DEVELOPMENT NO.:	21032932 – Appeal Item
APPLICANT:	Yuri Bezeruk
ADDRESS:	4 ROWE ST SOUTH BRIGHTON SA 5048
NATURE OF DEVELOPMENT:	Construct 2, two storey Houses in battle axe/hammerhead configuration, with retaining walls up to 1.6m and fence on top
ZONING INFORMATION:	Zones: <ul style="list-style-type: none"> • General Neighbourhood Overlays: <ul style="list-style-type: none"> • Airport Building Heights (Regulated) • Affordable Housing • Prescribed Wells Area • Regulated and Significant Tree • Stormwater Management • Traffic Generating Development • Urban Tree Canopy
LODGEMENT DATE:	10 Feb 2022
RELEVANT AUTHORITY:	Assessment panel at City of Holdfast Bay
PLANNING & DESIGN CODE VERSION:	2022.3
CATEGORY OF DEVELOPMENT:	Code Assessed - Performance Assessed
RECOMMENDING OFFICER:	Michael Gates Development Services (Planning and Building) Lead

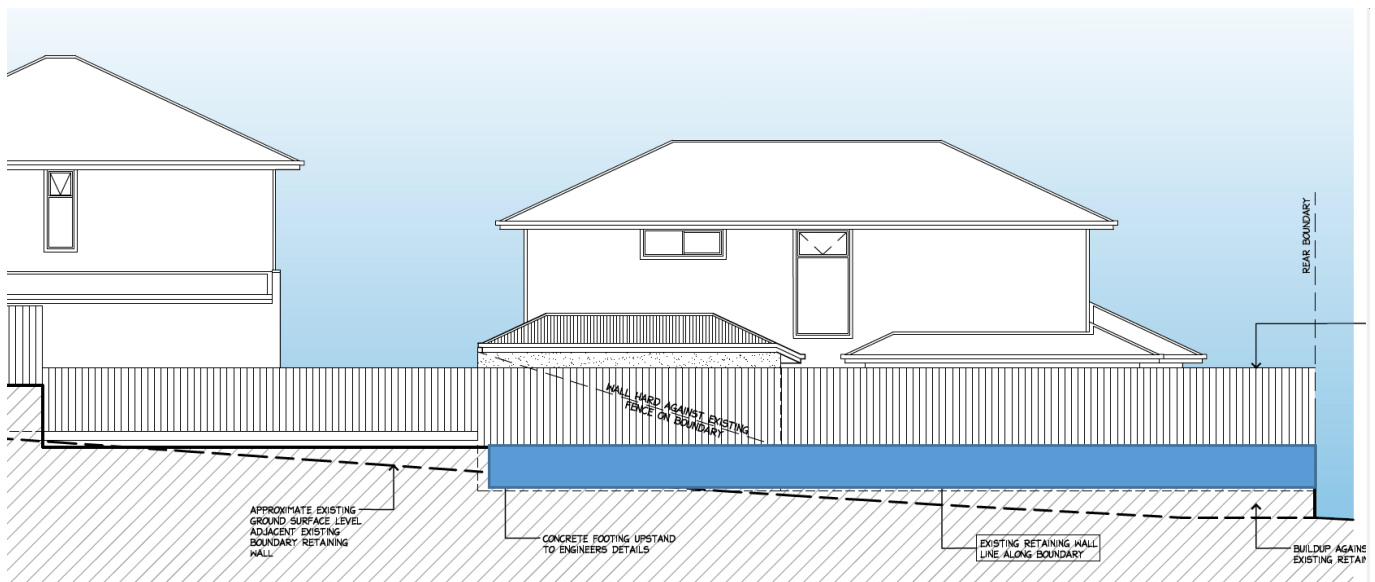
The applicant has provided further detail in regards to the level of the retaining wall on the neighbouring property to the east. House 2 will have a floor level approximately 600mm lower than the adjacent property to the east as shown on the plans below. The area shaded in blue represents the existing retaining wall on the eastern boundary that will sit above the proposed floor level of House 2, with the floor level of house 2 at the base of the blue shading.

The reduced floor level means that the amount of retaining on the site is no greater than a metre in height, and the combined wall and fence is no more than 2.8 metres. The reduction in floor level and retaining is considered to appropriately address reason reasons 1, 3, 4 and 6 for refusal.
